Southern Nuclear Operating Company
Vogtle Electric Generating Plant, Units 3 & 4
COL Application

Vogtle Electric Generating Plant, Units 3 & 4

Emergency Plan

Revision 3

Figure ii Vogle Electric Generating Plant Site Plan

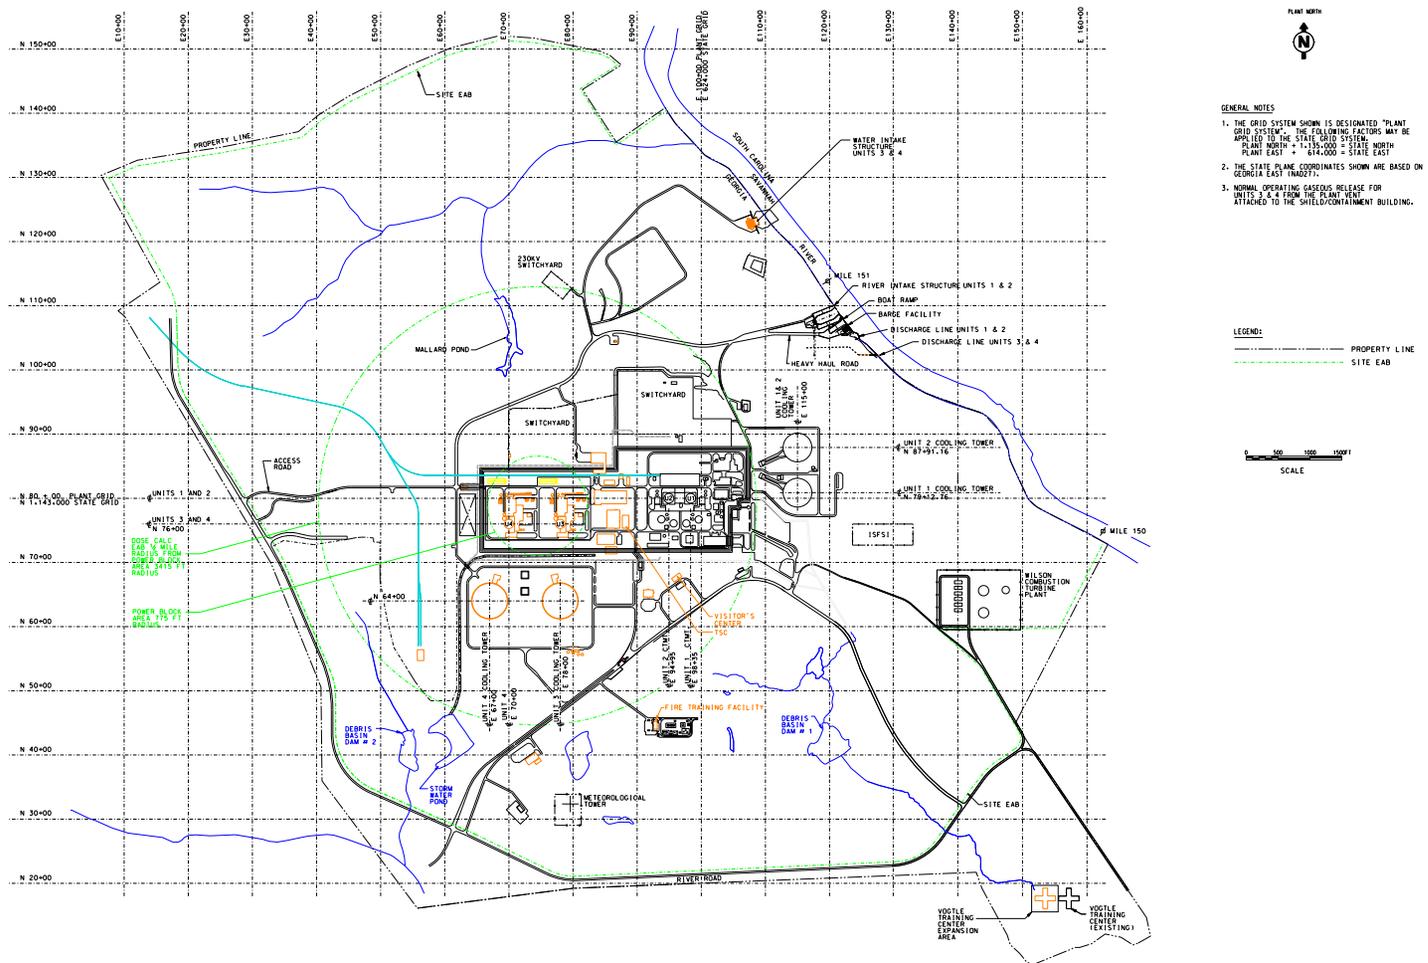
Replace Preface page xiii, Figure ii, Vogtle Electric Generating Plant Site Plan, with the attached Preface Figure ii.
